SERVICE BULLETIN
SUMMARY

ATA SYSTEM: 21

**TITLE: AIR CONDITIONING - CARGO COMPARTMENT HEATING - CHANGE
POSITION OF PRESSURE REGULATION VALVE**

MODIFICATION No.: 150447K12993

Figure A-GBBAD - Sheet 02

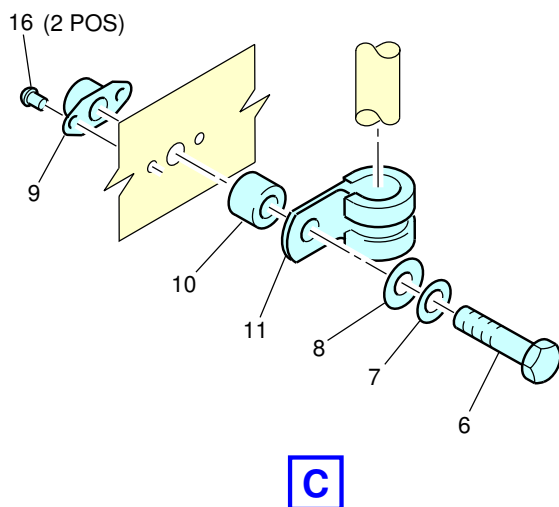
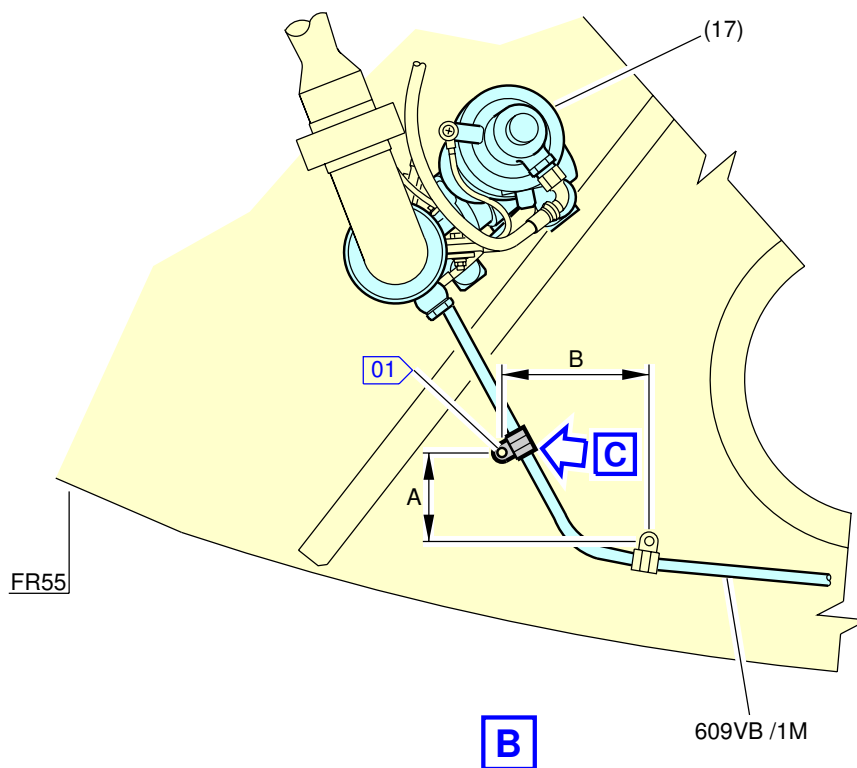
- (1) Modify the installed position of the Cargo Heat Pressure Regulating Valve, FIN 11HC, located between FR55 and FR56, LH.
- (2) Modify the routing for wire harness, 609VB/1M, at the Cargo Heat Pressure Regulating Valve, FIN 11HC, located between FR55 and FR56, LH.
